WARNING . . .

Description

The associated control box is a special modification of the MULTI-SCREEN controller to include the 6NO relay module (MSA-RM-6), the addition of trip/latch select, and the addition of quick disconnects for Emitter, Receiver, and machine interface.

Figure 21 Addition
Figure 21(s). Location and description of QD connectors

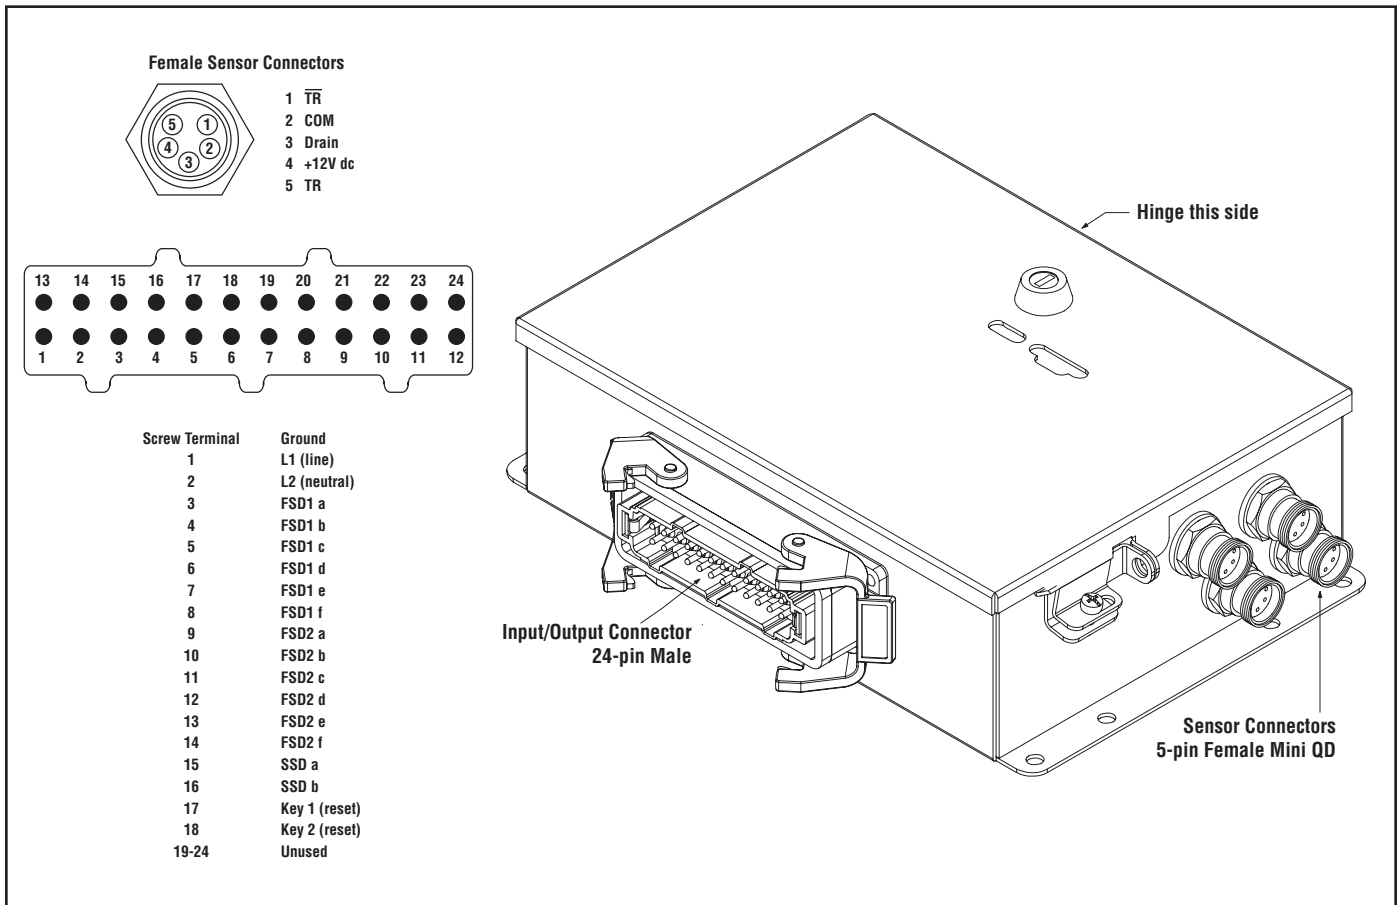
The Key Reset switch that is normally found on the control box front cover has been removed, and has been rewired to the Output Connector (see Figure 21(s) in this document). The user must supply a means to reset the MULTI-SCREEN system if a latch condition occurs (after clearing an interruption of the defined area), or after a lockout condition (see Section 5 of the primary instruction manual).

NOTE:
 The Key Reset switch has been removed and re-wired to terminals 17 and 18 of the Output connector to provide an external Key Reset.

See Figure 21 for description of 1-24 Output Connector and 1-5 Sensor Connectors (not shown).

Figure 26 Replacement
 Figure 26(s). Generic Machine Interface, MULTI-SCREEN System

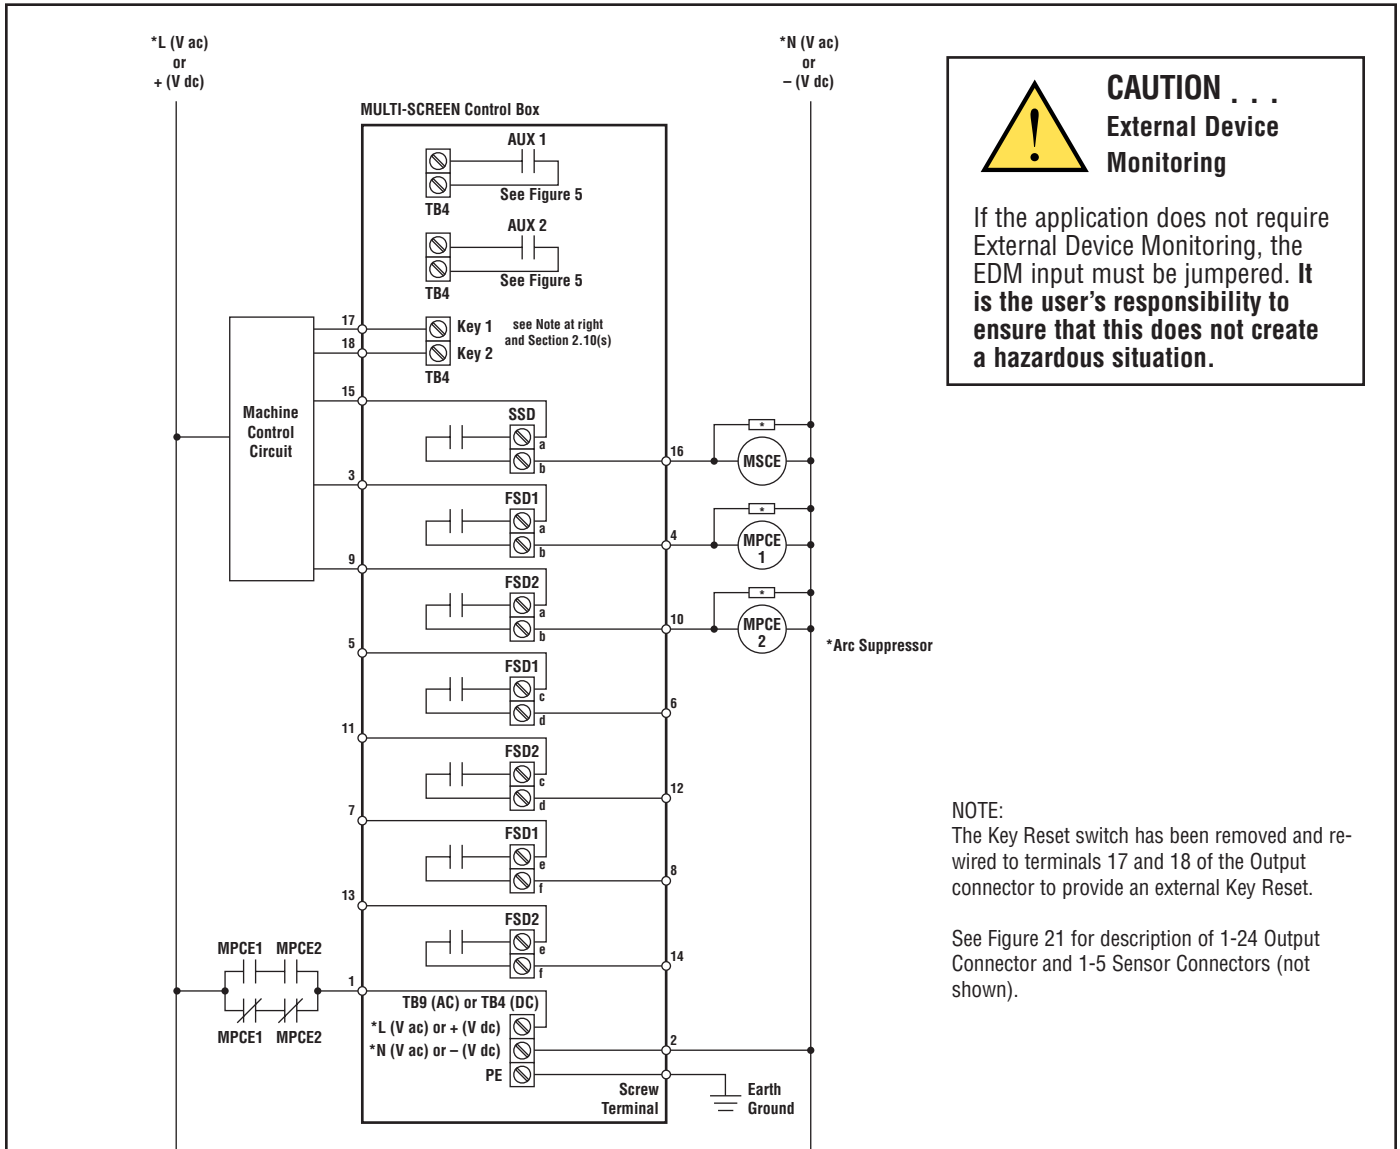
One contact from each relay (FSD1 and FSD2) must be used together, as shown in Figure 26(s), to control each individual hazard.

One contact from each relay (FSD1 and FSD2) must be used together, as shown in Figure 26(s), to control each individual hazard. Each FSD output consists of a single normally open contact from one relay; **contacts from both FSD relays must be used to ensure proper operation.**

If arc suppressors are used, they must be installed as shown across the coils of the safety relays. It is possible for suppressors to fail as a short circuit.

Figure 26(s) shows hookup for only one hazard to be controlled. For additional MPCEs (i.e., MPCE3/MPCE4, and MPCE5/MPCE6), duplicate hookup as drawn for MPCE1/MPCE2.
